RECEIVED JUN 08 2018
Chemung County Planning Board

Durkin Donuts

Preliminary Site Plan Review

Re: Site Plan Approval For 3317 Chambers Road **Dunkin Donuts Restaurant**

1 SITE IMPROVEMENT PLAN
SCALE: 1"=10'

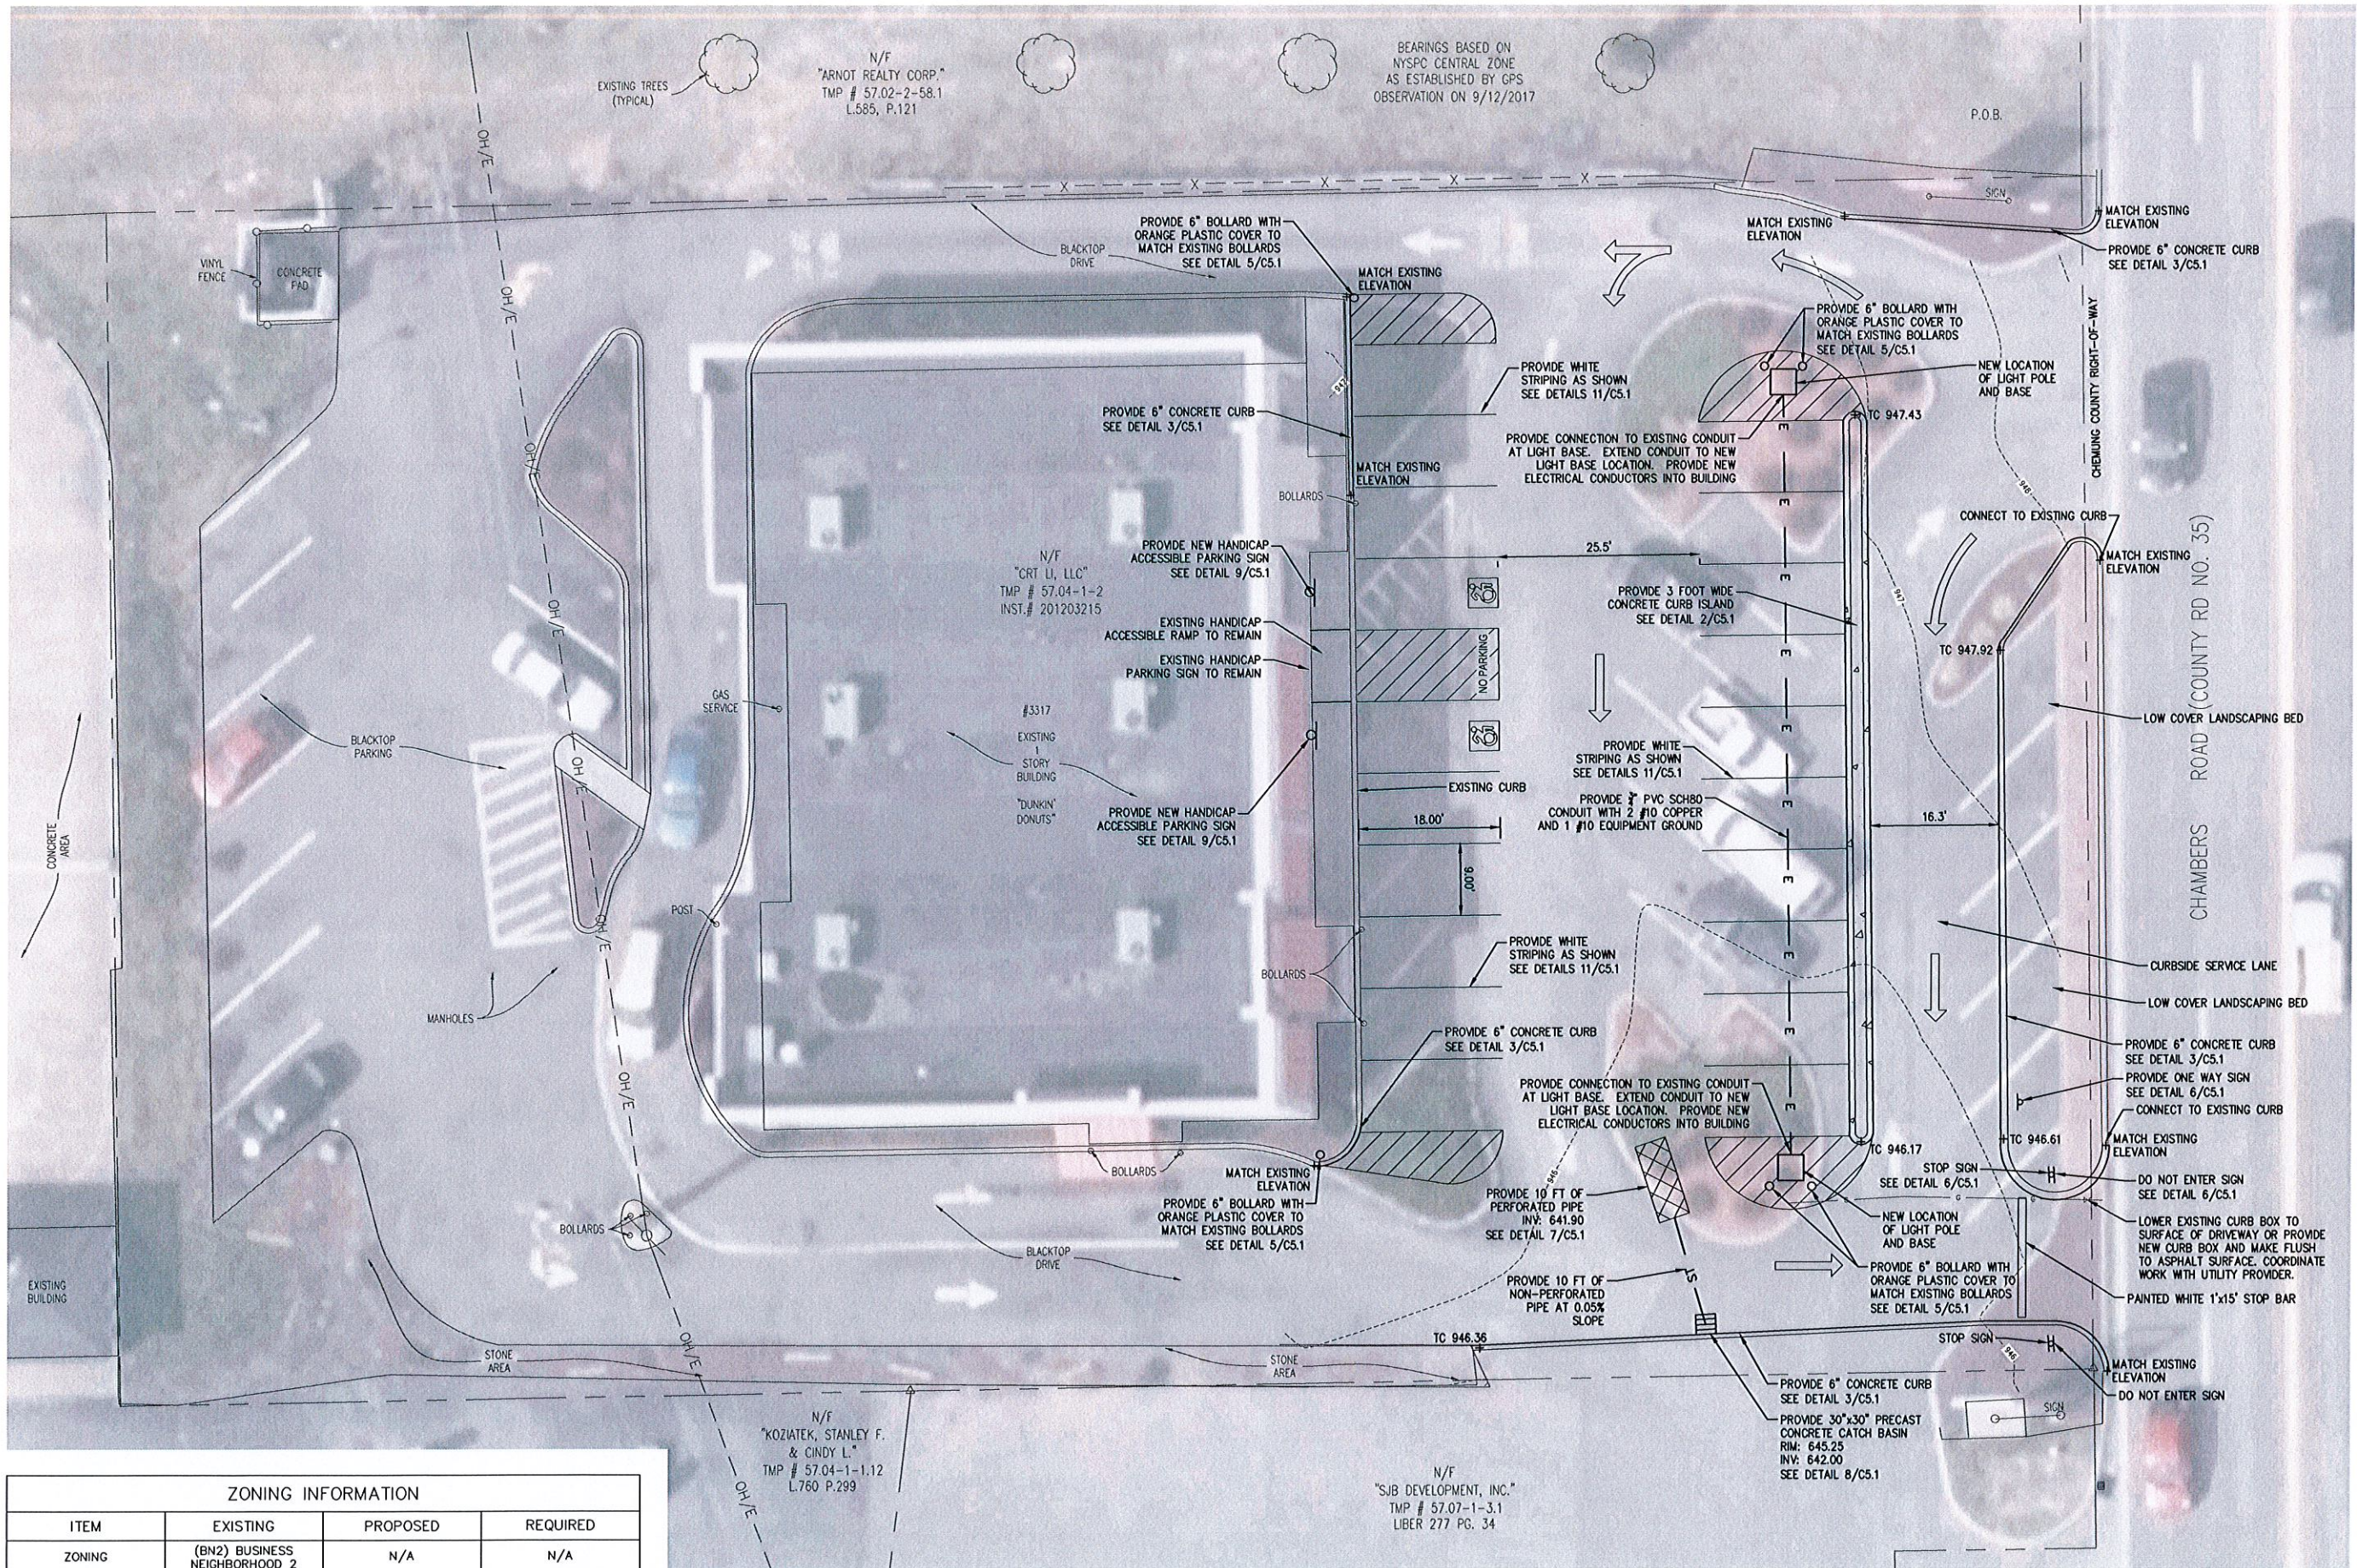
- A. Applicant provided zoning information table. The zoning district is incorrectly shown as BN2- Business Neighborhood 2, the correct zone for the project is BR- Business Regional. The current lot coverage, as provided by the applicant is 77.96% with a proposed coverage of 82.6%. The maximum lot coverage for the BR District is 70%. As a result, the site is an existing nonconformity. The applicant will need to obtain an area variance to increase the lot coverage from the existing conditions. However, as recommended in comment B below, we believe the layout of the site can be adjusted to reduce the lot coverage to be at or below the existing lot coverage.

- B. The driveway in front of the existing store is proposed to be 25.5' wide but is proposed to be only one way, with a curbside service lane located to the East. The purpose of this curbside service lane is unknown. A recommendation would be to eliminate this curbside service and lane and provide a landscape island in this space with a dedicated parking space in front of the store for curbside pick-up. By removing the curbside service lane, the drive-aisle in front of the store can be widened and the landscaped island along Chambers Road can be reconfigured and increased in size. This will allow for a reduction in lot coverage potential to existing levels. As we have recommended previously, the northern most driveway on Chambers Road is poorly configured to direct the flow of traffic. By removing the curbside service lane, the driveway can be modified to allow for safer and more direct traffic circulation patterns into the site.

- C. The applicant is proposing to reconfigure parking lot islands, which will change the flow of runoff for this site. Grading and Drainage information should be provided for review. As noted above, the amount of greenspace is being reduced for this site. The applicant shall provide calculations to show that the perforated pipe system is adequate to handle the amount of runoff being directed to this system.

- D. The project is planned to remove existing pavement and landscape islands. The disturbance will be under 1 acre, but the applicant should prepare an erosion and sediment control plan to denote BMPs that will be used to prevent sediment transport during construction.

- E. Applicant to provide ADA access route slope from the parking areas to the building to ensure compliance with ADA requirements.
- F. A detail shall be provided at the joint between the existing pavement and the new pavement at the sawcut lines.

- G. A photometric plan shall be provided to reflect the new light pole locations to ensure compliance with lighting requirements outlined in the code.

- H. A landscaping plan shall be provided to show proposed landscaping. It appears that all of the existing landscaping within the parking lot will be removed as part of the improvements. Per Section 17.48.010 (O)(10), one (1) shade tree of not less than three inches caliper for each six parking spaces is required. As a result, the applicant will need to provide 5 shade trees or request a variance.

- I. The improvements appear to extend onto Chambers Road. Any improvements within the County ROW will required approval from the County Public Works.
- J. The applicant provided a truck turning plan utilizing a 30' box truck approaching from the North. It is anticipated the truck delivers will come to the site from the Interstate 86 and Chambers Road intersection to the south of the site. As a result, the truck should be shown entering and exit from that direction. The largest possible delivery truck should be used to demonstrate access. The existing use will have full size tractor trailer deliveries. The ability for an emergency vehicle to access the front of the building from either direction is unknown.
